HISTORIC AND DESIGN REVIEW COMMISSION

July 19, 2023

HDRC CASE NO: 2023-258
COMMON NAME: 145 NAVARRO
ADDRESS: 219 VILLITA ST
LEGAL DESCRIPTION: NCB 986 LOT 11 THRU 13 AND E 5.14FT OF 10
ZONING: D, H, RIO-3
CITY COUNCIL DIST.: 1
APPLICANT: Peter Ketter/Sandvick Architects
OWNER: Kunal Mody/145 NAVARRO LLC
TYPE OF WORK: Amendment to previously approved design of rooftop addition; infill of windows
APPLICATION RECEIVED: June 30, 2023
60-DAY REVIEW: August 29, 2023
CASE MANAGER: Edward Hall

TITLE:
Penthouse & Lightwell Elevations

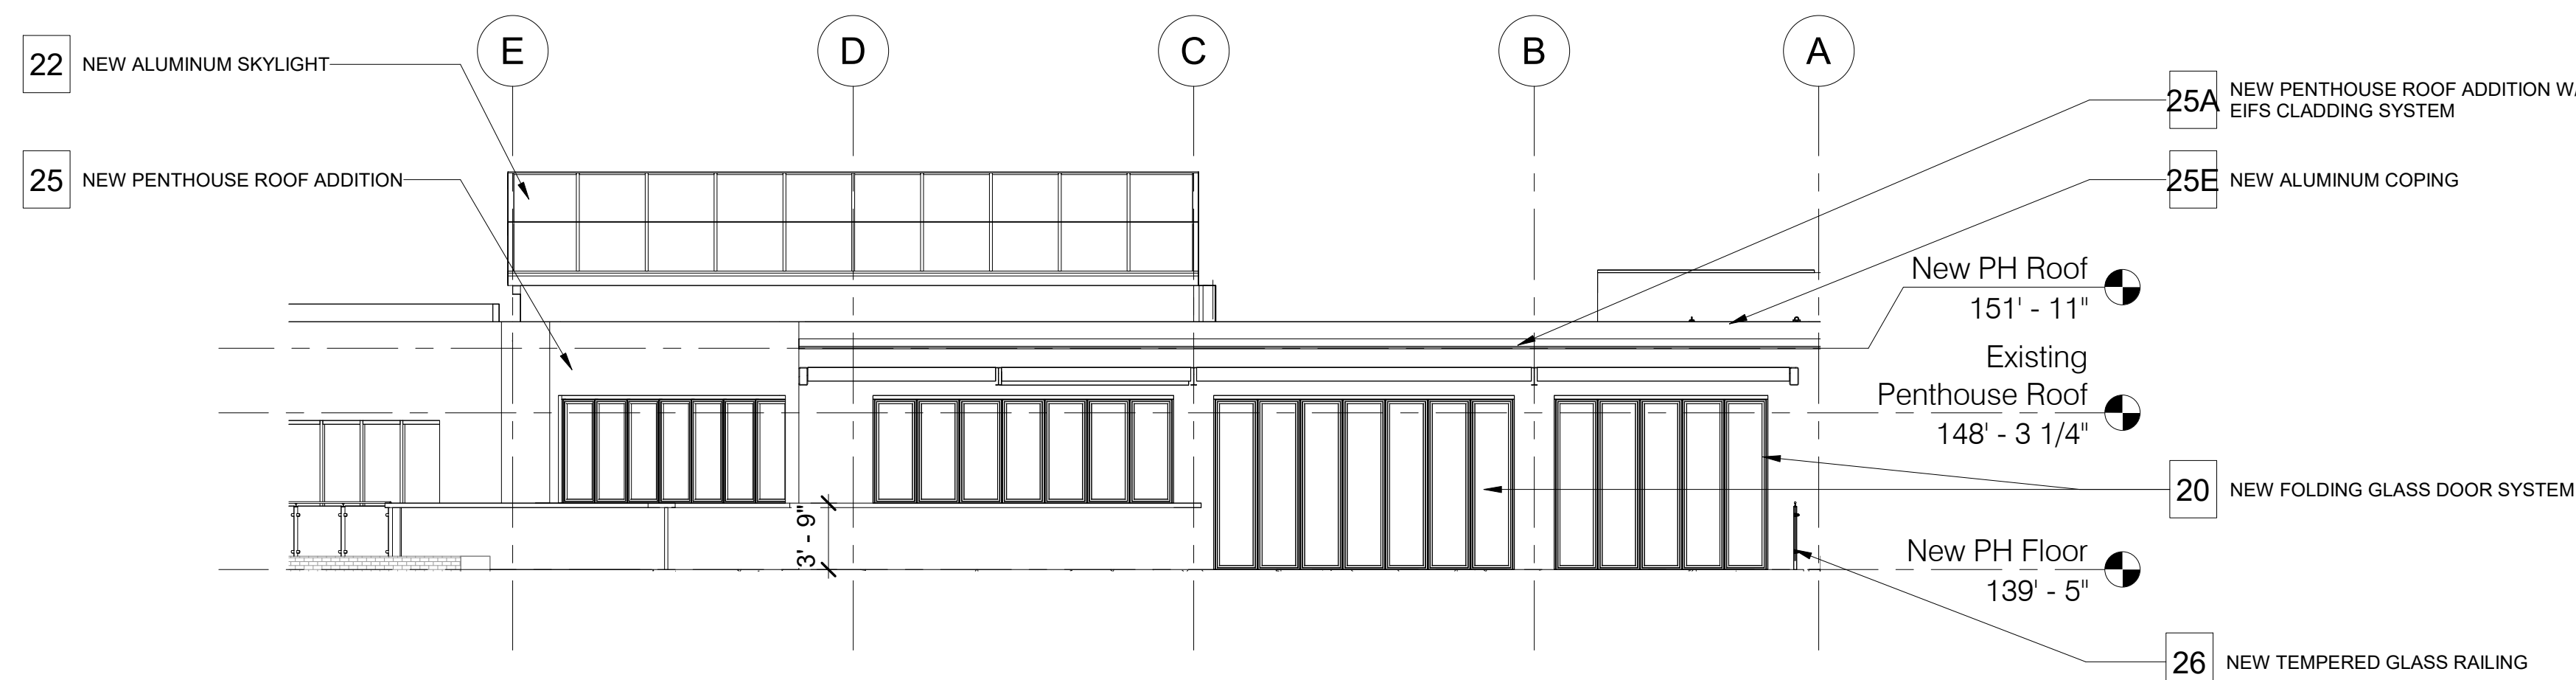
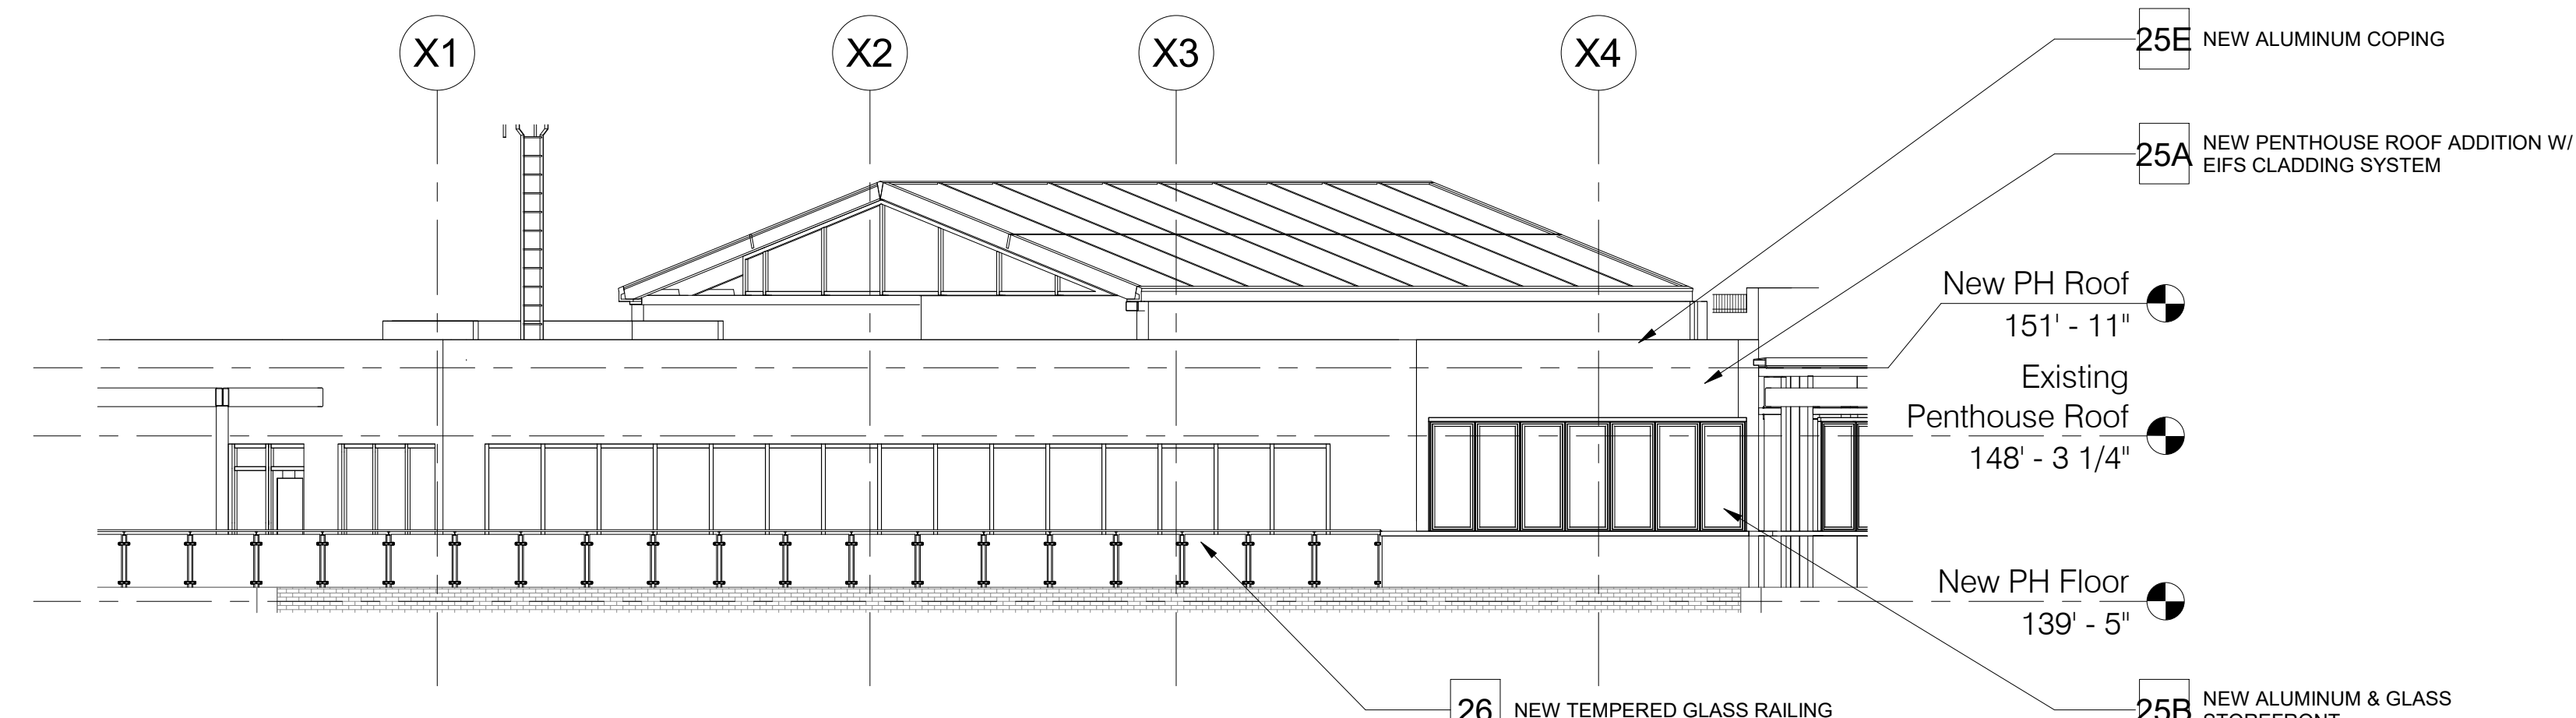
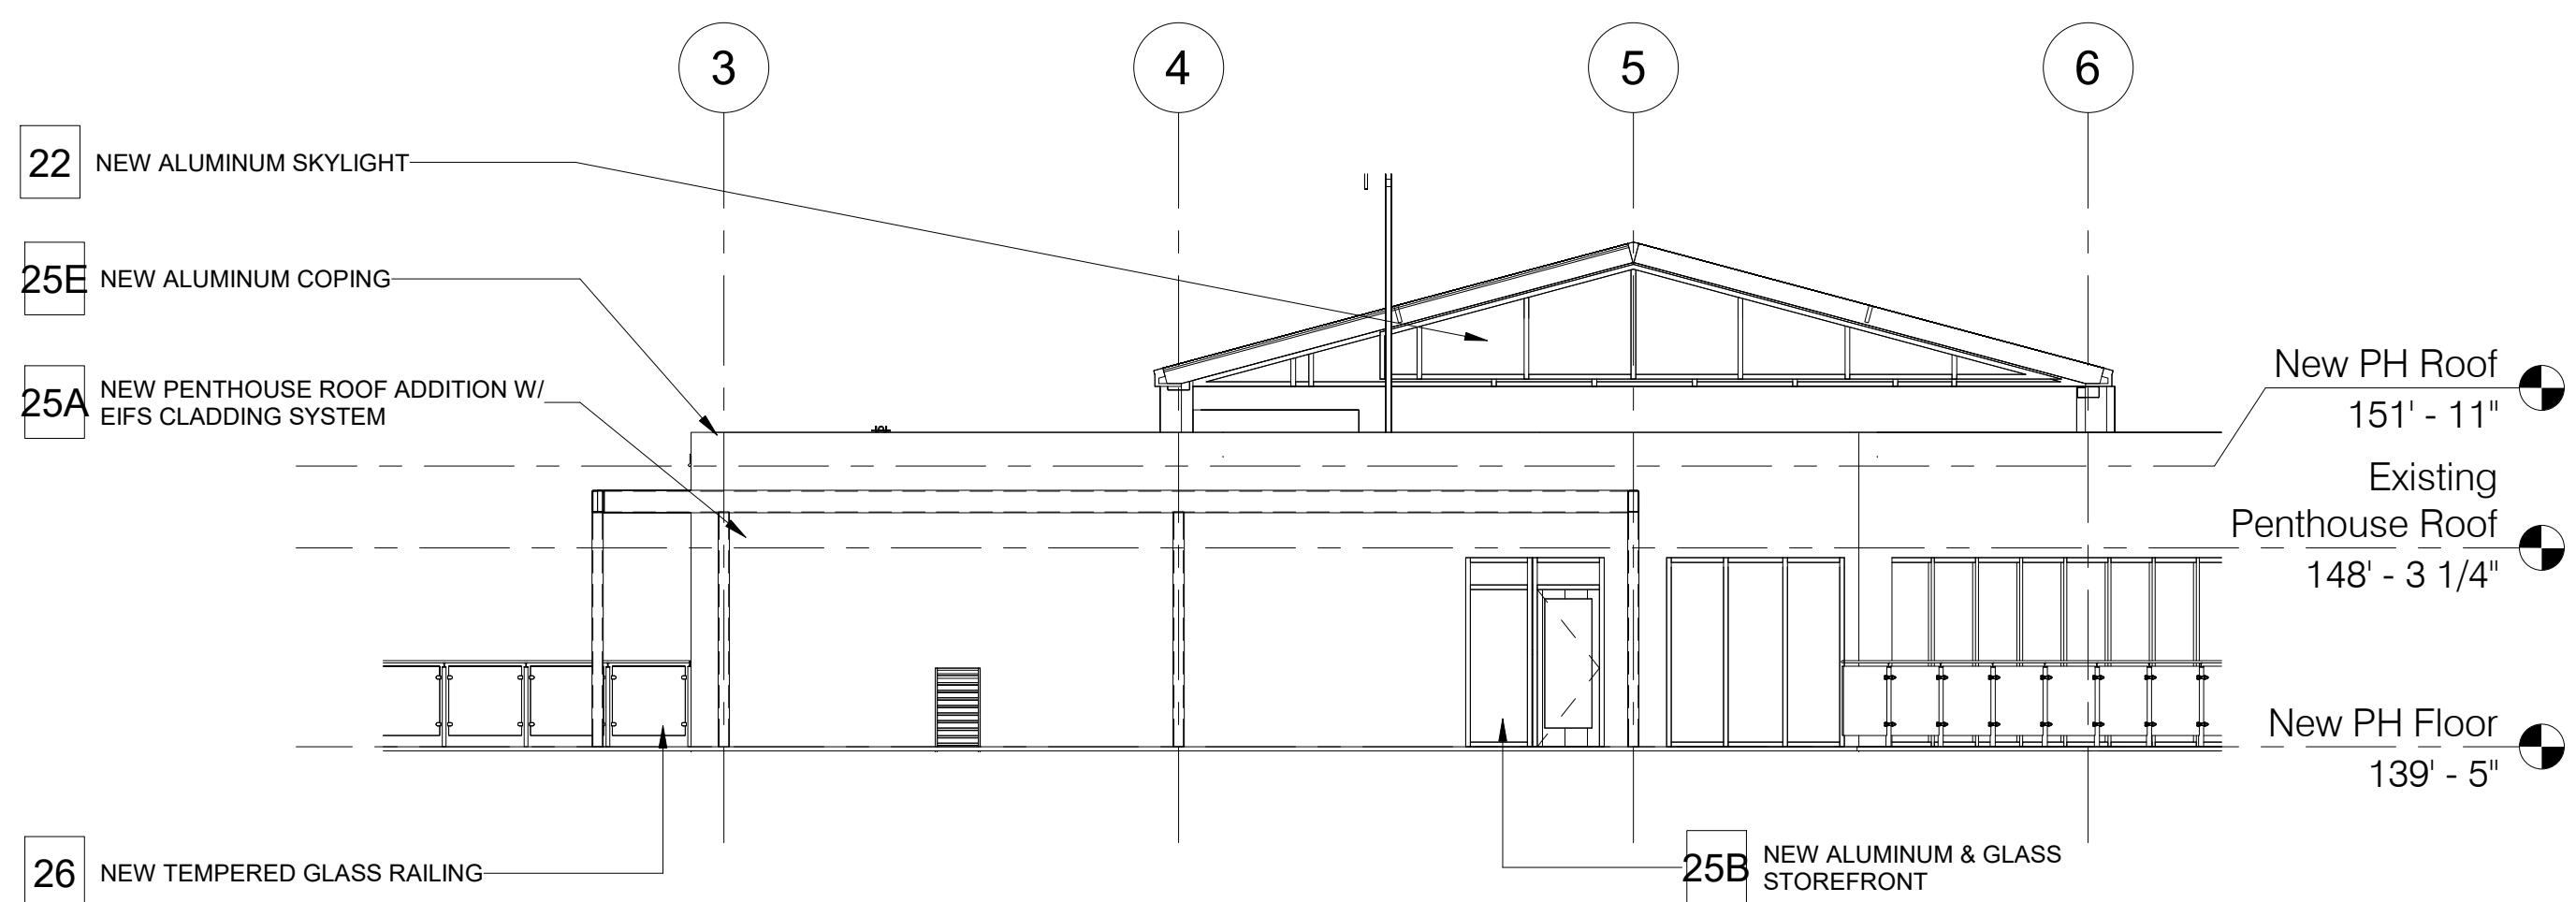
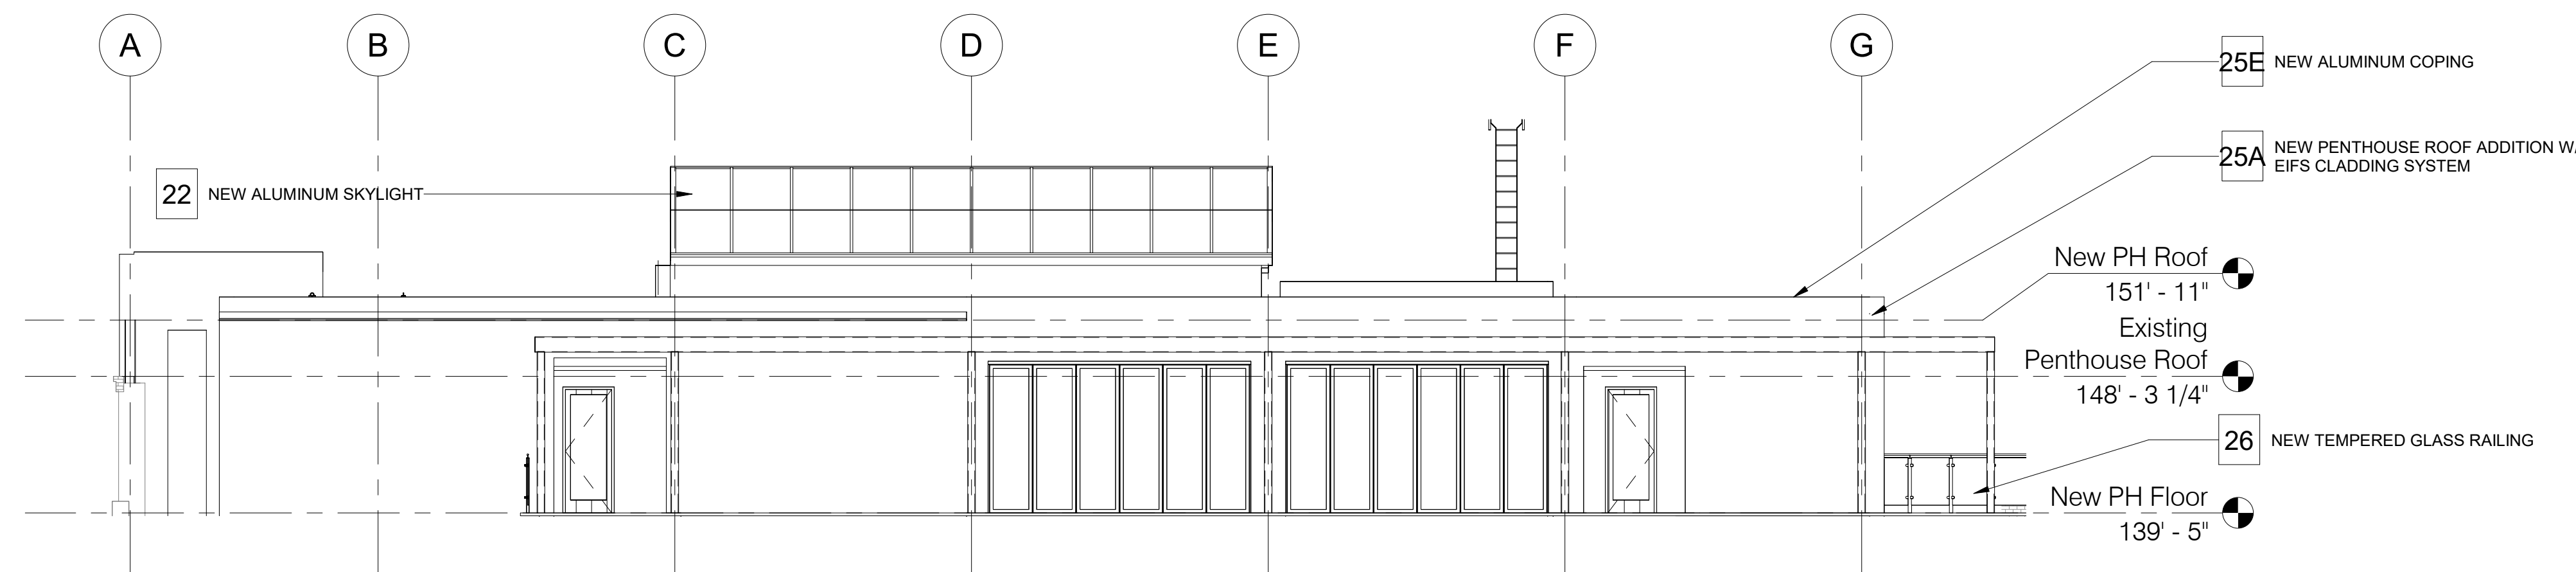
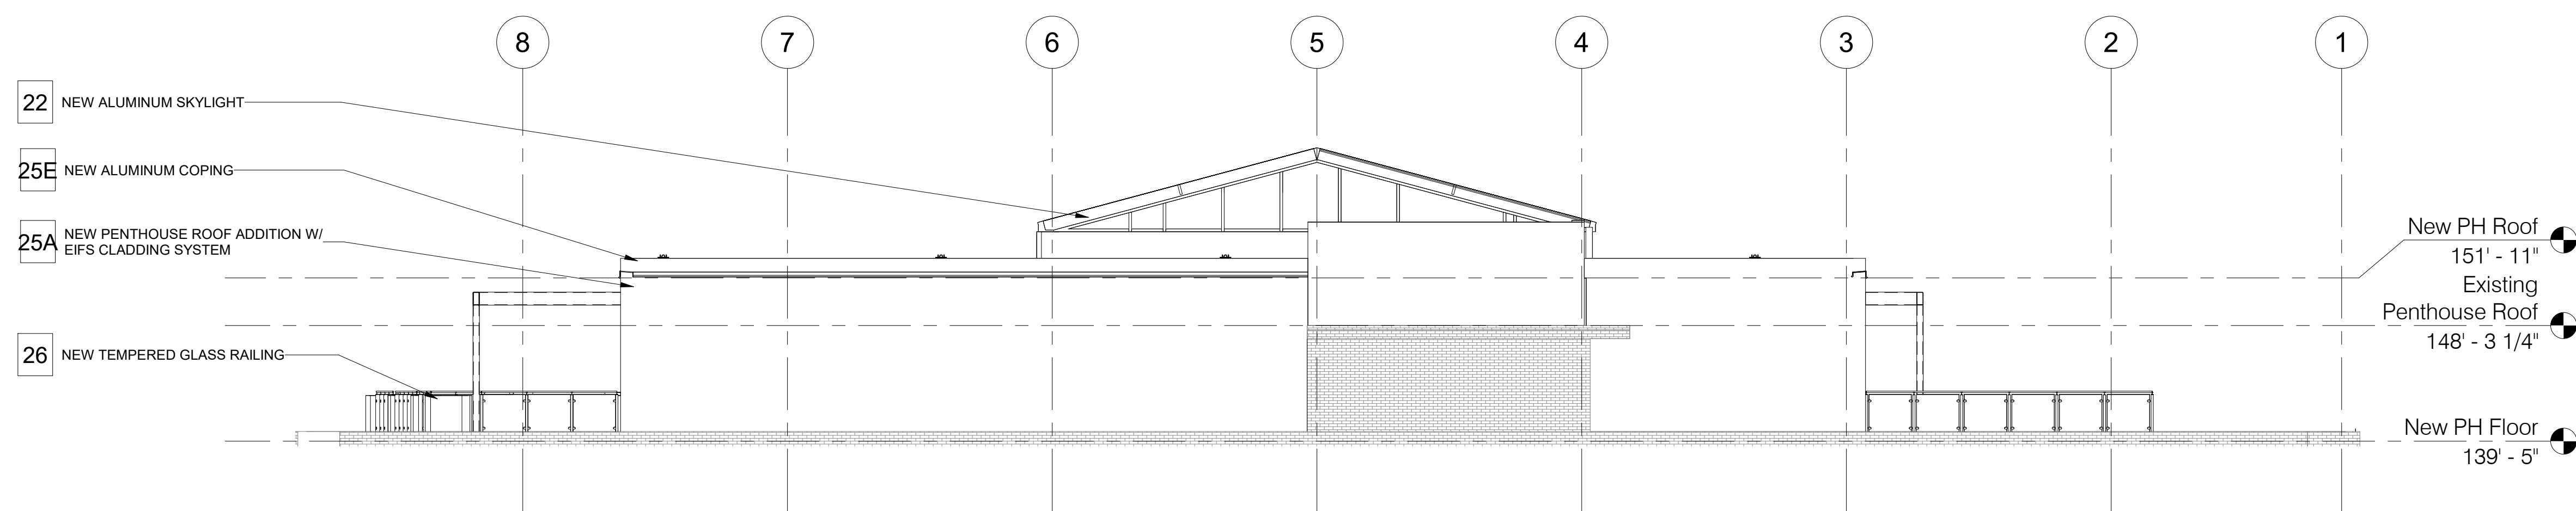
- d. ROOFTOP ADDITION – The applicant has proposed to modify the façade arrangement of the rooftop addition and increase the height of the elevator penthouse. Per the revised construction documents, the penthouse will now feature a folding glass door system and EIFS cladding. Generally, staff finds the proposed revisions to be appropriate; however, staff finds that if EIFS is used, it should feature a finish and control joints similar to traditionally applied stucco/plaster.

- 1. Staff recommends approval of item #1, the infill of non-original window openings on the west façade as noted in finding c.
- 2. Staff recommends approval of item #2, modifications to the design and height of rooftop additions based on finding d with the following stipulation:
 - i. That EIFS feature a finish and control joints similar to traditionally applied stucco/plaster.
- 3. Staff recommends approval of item #3, modifications to the proposed right of way parkway based on finding e with the following stipulation:
 - i. That street trees or landscaping beds be installed in the parkway. The applicant is to follow the Downtown Design Guide’s sidewalk and street planting standards as outlined in Chapter 2, Section A and Chapter 8, Section E.
